ANALYSIS SUMMARY CALCULATION

The following summary calculation was generated from the results of a CRANE GIRDER PRO structural analysis. The crane girder failed due to the type of cracks shown in Photograph #4 of the section on Crane Girder Failure. The analysis resulted in the replacement of over 10 crane runway girders in length of 50 ft. and 75 ft.

EXISTING GS MODEL ANALYSIS

EXISTING GIRDER EVALUATION COMMENTS GSEXFLD 4

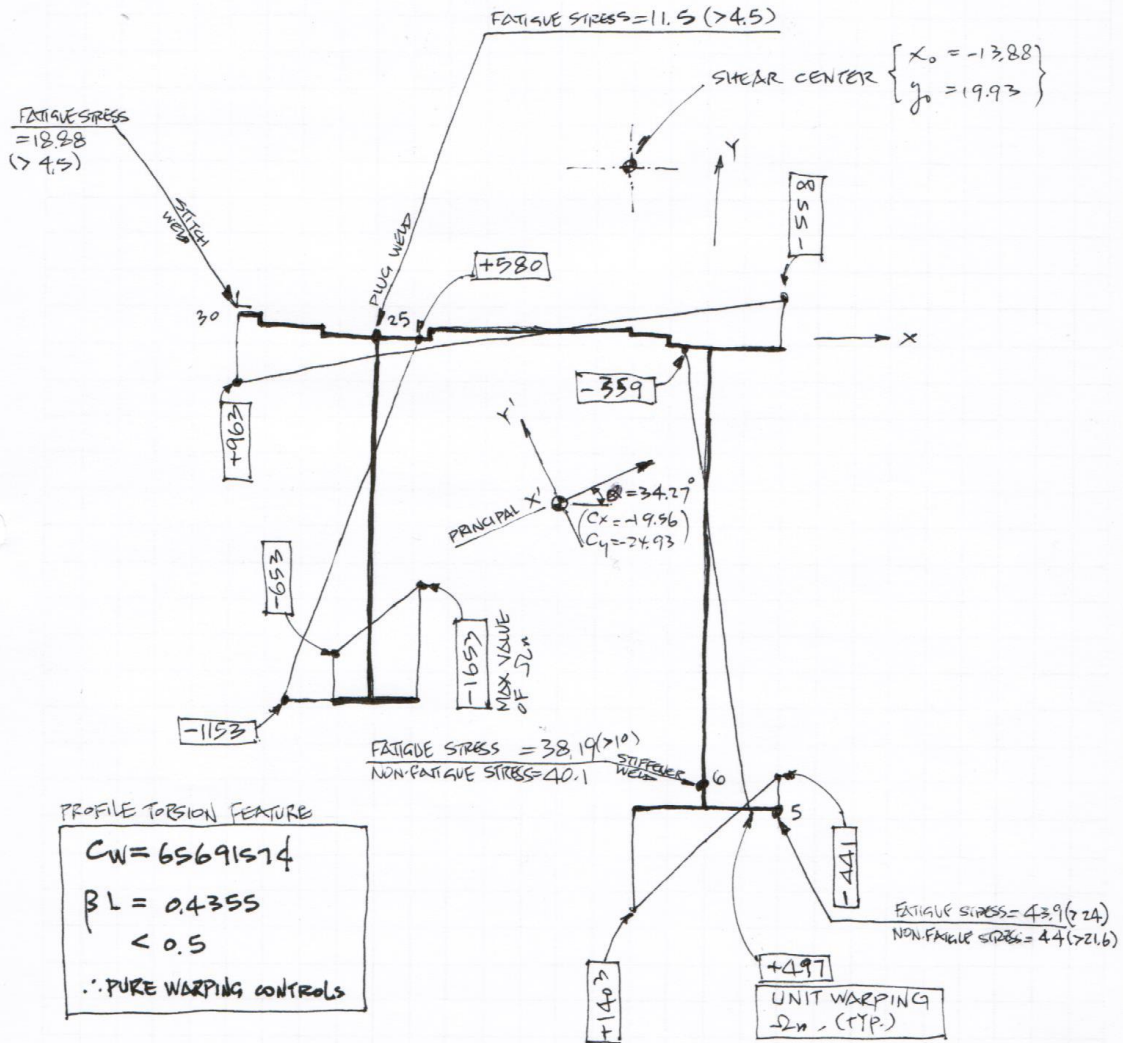
1. GIRDER PROFILE RESEMBLES AN UPSIDE-DOWN U OR A LAY-DOWN CHANNEL SECTION, FOR WHICH THE SHEAR CENTER IS WAY ABOVE THE CHANNEL WEB. THEREFORE THE ENTIRE GIRDER SECTION IS PREDISPOSED TO ROTATE ABOUT THE SHEAR CENTER WHEN LOADED AT TOP OF THE RAIL FROM THAT THE RESULTANT "RARELY" PASSES THROUGH THE SHEAR CENTER.

2. TORSION CHARACTERISTIC CONSTANT $\beta = 0.0007258$, LENGTH $L = 600$. $\beta L = 0.4355$. ANY SUCH βL MAGNITUDE, LESS THAN 0.5, WOULD CLEARLY INDICATE THAT ST. VENANT TORSION (COMPARING WITH WARPING) IS RELATIVELY MUCH TOO SMALL TO HAVE PRONOUNCED EFFECT. THEREFORE THE GIRDER'S TORSIONAL BEHAVIOR WOULD BE CONTROLLED BY "PURE WARPING".

3. FIBER STRESS AT NODES IN THE BOTTOM FLANGE AND THE LOCALITY IS GENERALLY HIGHER THAN THAT ELSEWHERE. THIS IS TRUE FOR ALL ZONES DUE TO THE FACT THAT THE DISTANCE TO THE CENTROID AND/OR SHEAR CENTER FROM THESE NODES ARE INHERENTLY FARTHER THAN THAT FROM OTHER NODES.

4. EXCEPT FOR THE END ZONES (1, 2, 20, 21) UP TO ABOUT 5 FT FROM THE SUPPORTS, THE GIRDER IS FOUND OVERSTRESSED UNDER NON-FATIGUE LOAD AT VARIOUS HOT SPOTS IN ALL OTHER ZONES. TYPICALLY, HOT SPOT INCREASES IN NUMBER FROM MINIMA IN ZONE 3/19 TO THE MAXIMA TOWARDS CENTER ZONE 11.

5. SUBJECTED TO REPEATED STRESS FLUCTUATIONS, THE BASE METAL SHOULD DEVELOP CRACKS AT MOST HOT SPOTS ESPECIALLY IN ZONE 11. LISTED AS FOLLOWS ARE SOME OF THE HIGHEST RATIO OF BASE METAL FATIGUE STRESS (REVERSAL) TO DISC ALLOWABLE FSR VALUES UNDER FATIGUE LOAD CONDITION 4 ARE:

4.2 (= 18.8 / 4.5)	}	AT NODE 30 - KICK ANGLE / # STITCH WELD
3.82 (= 38.19 / 10)		6 - WEB STIFFENER BASE WELD
2.56 (= 11.5 / 4.5)		25 - SUPPORT BEAM / # PLUG WELD
1.83 (= 43.9 / 24)		AT NODE 5 - BOTTOM FLANGE TIP (NO WELD)
